Item Name: AH-1F/P/S Replacement Skidtube with Standard Wearplates, Fits LH or RH

DRAWING NO. D2906	TITLE AH-1 (209) SKIDTUBE ASSEMBLY	REV. B	DART AEROSPACE LTD ENGINEERING ORDER		D.E.O. NO. D2906-B-1	SHEET NO. SHEET 1 OF 1	SCALE NTS
DRAWN A.P.	CHECKED <i>[Signature]</i>	MFG. APPR. <i>[Signature]</i>	APPROVED <i>[Signature]</i>		DE APPR. <i>[Signature]</i>		
DATE 12.05.28	DATE 12.05.28	DATE 12.05.31	DATE 12.05.31		DATE 12.05.31

CHANGE ALL C'BORED WELDED CROSSBOLT SPACERS TO SWAGED SPACERS

SECTION C-C A2-2
NOT TO SCALE A2-3

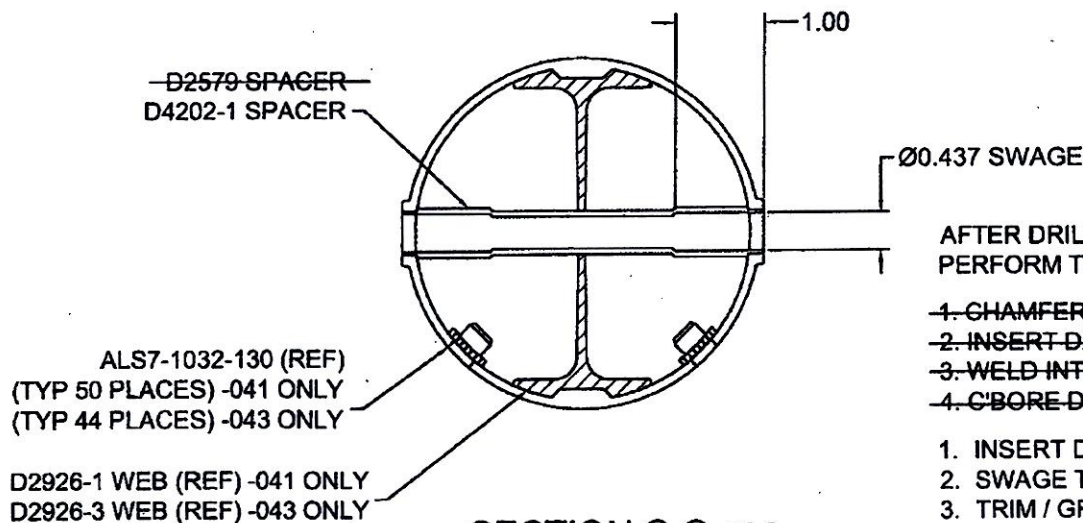
SECTION C-C ON SHEETS 2 & 3 ARE AMENDED AS FOLLOWS FOR ALL HOLES THAT WERE ORIGINALLY C'BORED:

- ~~1. CHAMFER HOLE 0.050 X 45°~~
- ~~2. INSERT D2579 SPACER (20 PLACES)~~
- ~~3. WELD INTO PLACE AND GRIND FLUSH~~
- ~~4. C'BORE D2579 SPACER TO Ø0.437 X 1.00 DEEP~~

1. INSERT D4202-1 SPACER, 22 PL (-041) OR 19 PL (-043)
2. SWAGE TO Ø0.437 X 1.00 DEEP PER QSI 002
3. TRIM / GRIND FLUSH PER QSI 002
